October 18, 2001

SUBJECT: COMPLETION OF STAFF REVIEWS OF NRC BULLETIN 96-03,  
"POTENTIAL PLUGGING OF EMERGENCY CORE COOLING  
SUCTION STRAINERS BY DEBRIS IN BOILING-WATER REACTORS,"  
AND NRC BULLETIN 95-02, "UNEXPECTED CLOGGING OF A  
RESIDUAL HEAT REMOVAL (RHR) PUMP STRAINER WHILE  
OPERATING IN SUPPRESSION POOL COOLING MODE" (TAC  
NUMBER MA0704)

**Figure 1: NRCB 95-02 Responses on Last Suppression Pool Cleaning**

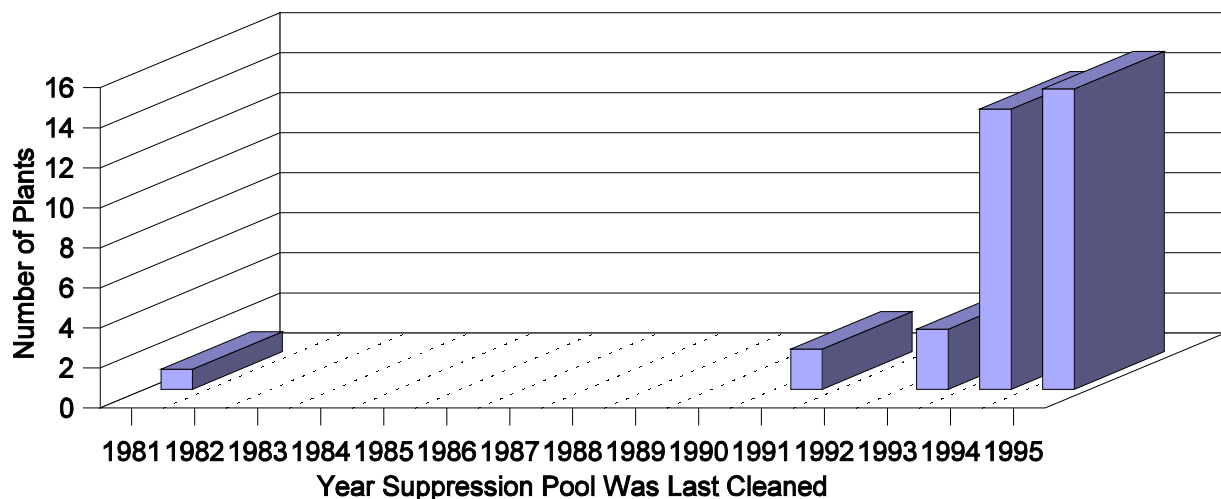
Addressees were requested to respond to the NRCB 95-02 within 30 days. We received responses for 37 BWRs. The Containment Systems and Severe Accident Branch (SCSB) performed an initial screening of all responses. Figure 1 summarizes the bulletin responses as to when licensees had last cleaned their suppression pools (as of the date of their initial responses to NRCB 95-02).

Figure 1 clearly shows that BWR licensees had, in fact, been cleaning their suppression pools. One exception was Nine Mile Point, Unit 1 (NMP-1). Figure 1 does not include Big Rock Point because their design does not have a suppression pool, and Browns Ferry, Unit 1, who was in an extended shutdown at the time of their response. Tennessee Valley Authority (TVA), the licensee for Browns Ferry, stated in their response that they would address the bulletin issues for Unit 1 before restarting the plant.
